PREVOST

SAFETY RECALL

Sr10-19

SUBJECT: RICON F9TF WHEELCHAIL LIFT SAFETY BELT

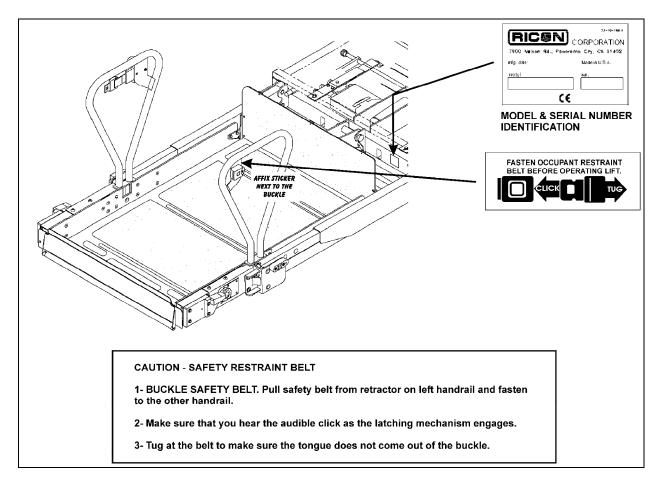
Hazardous situation awareness: Failure to hear an audible click as the latching mechanism engages. If tugged the tongue will come out of buckle.

Instruct the wheelchair lift operator to check that the buckle is properly engaged as per the instruction found on the image below. A DVD-based training aid to promote the "Click and Tug" campaign is available if needed.

Prevost asks its customers to install a warning sticker on the handrail next to the buckle in accordance with Ricon's safety recall procedure.

- 1. Validate that your Ricon wheelchair list system is model F9TF with serial number included in the list above. If your wheelchair lift system serial number is not among the list, do not consider the safety recall campaign. If your F9TF wheelchair lift system serial number is among the list, you must order the "Click And Tug" sticker #864173 from Prevost. Note down your Ricon wheelchair lift serial number, you will have to provide it with your claim form.
- 2. Affix the sticker onto the handrail next to the buckle as shown on the image below. Do not affix the sticker on the restraint belt.
